MEMORANDUM

Re: YarrowBay's Reply and Rebuttal to Wetland Comments Regarding The Villages MPD Preliminary Plat Phase 2 Plat C (PLN13-0027)

WETLAND RESOURCES, INC. TECHNICAL MEMORANDUM

Re: Response to Three Touchstone Ecoservices (TES) December 19, 2014 letters and Lider Engineering December 15 and 17, 2014 letters

WETLAND E1 DRAINAGE BASIN EXHIBIT

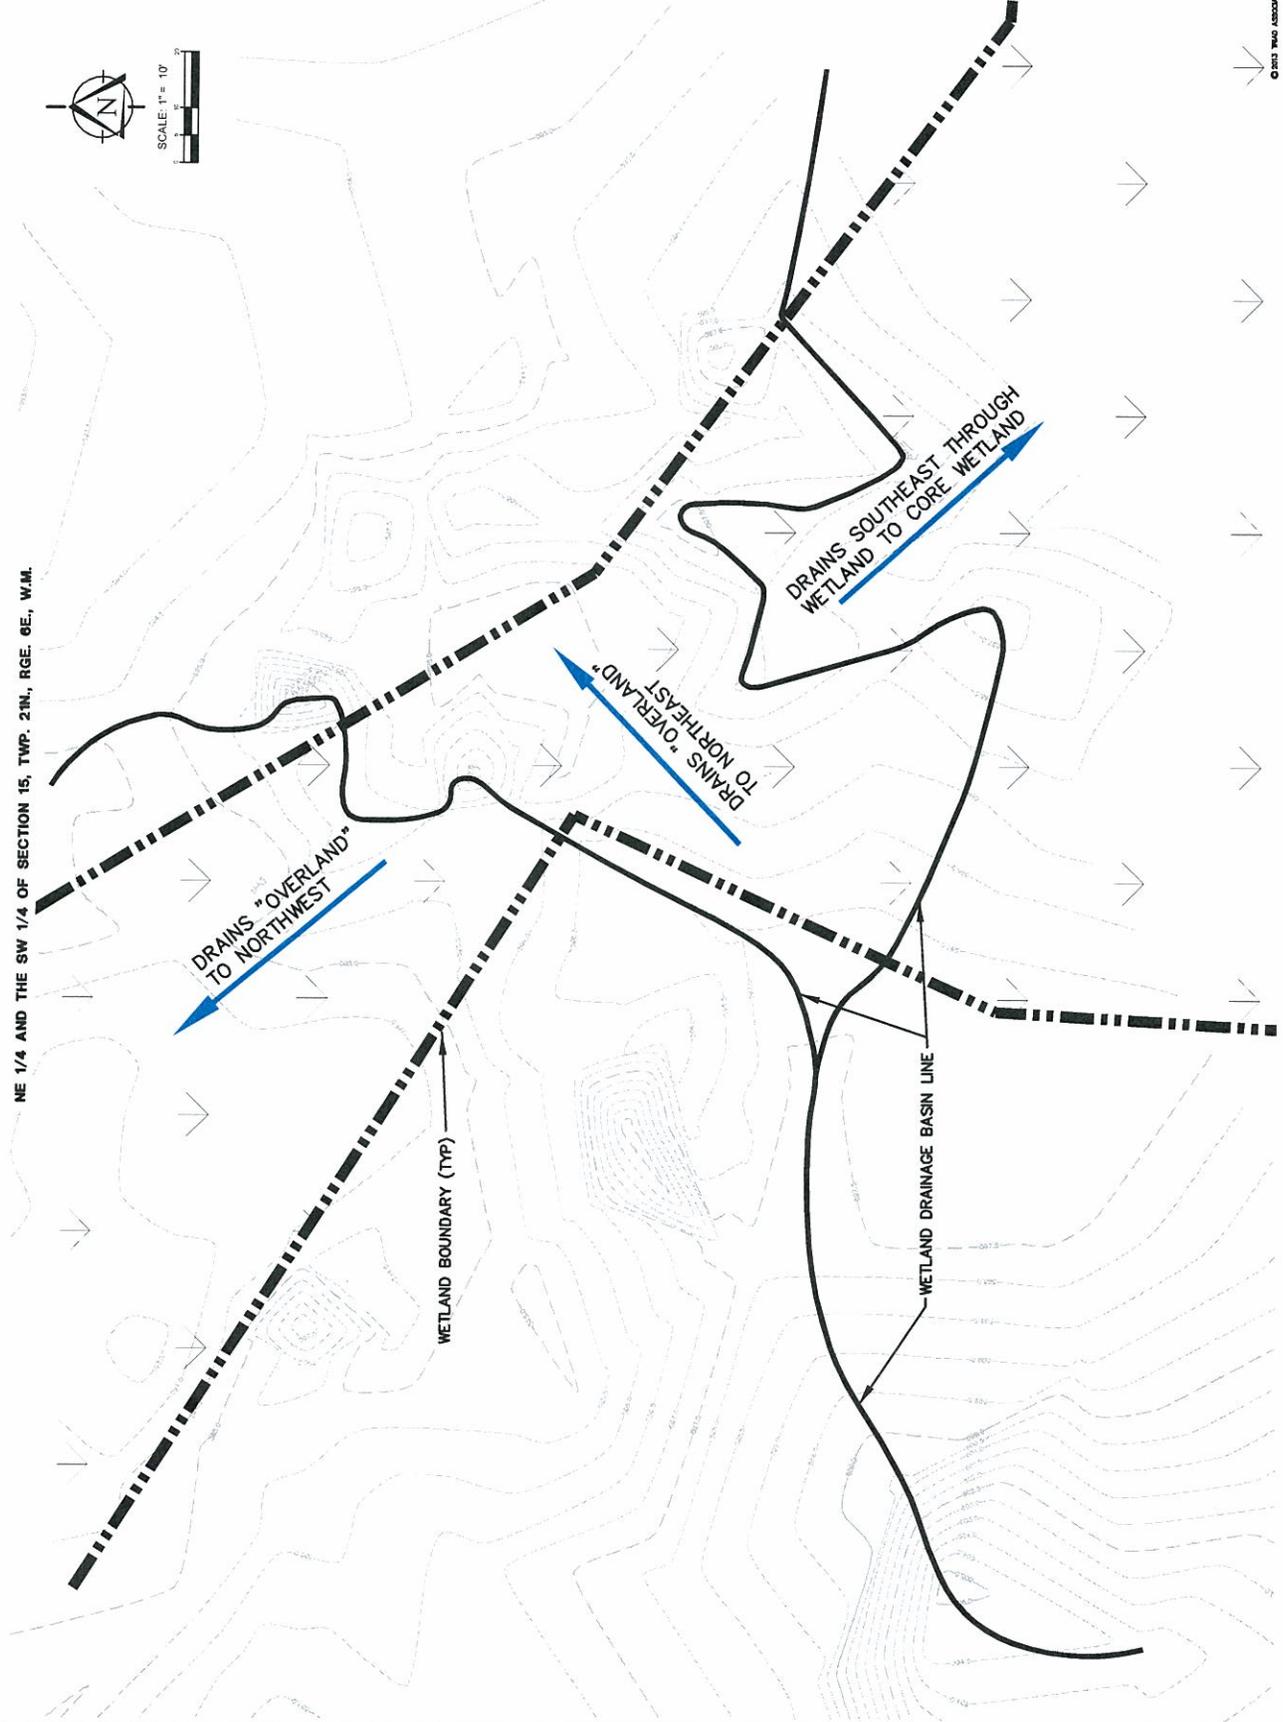
See Triad analysis at pages 188-189 of Exhibit 28 to Staff Report. This analysis led to the clear conclusion that the hydrology in Wetland E1 flows to the northwest, away from the Core Wetland Complex associated with Rock Creek (see attached Wetland Drainage Basin Exhibit prepared by Triad and Associates). This flow pattern is readily discernable in the field and was observed during one of the multiple site visits conducted by Wetland Resources, Inc. and Perteet, the City’s wetland consultant. Given this distinct basin divide, monitoring of hydrology over a period of a year would provide no salient data related to the separation of the Wetland E1 Unit to Wetland TOS, nor does the Washington State Department of Ecology Wetland Rating
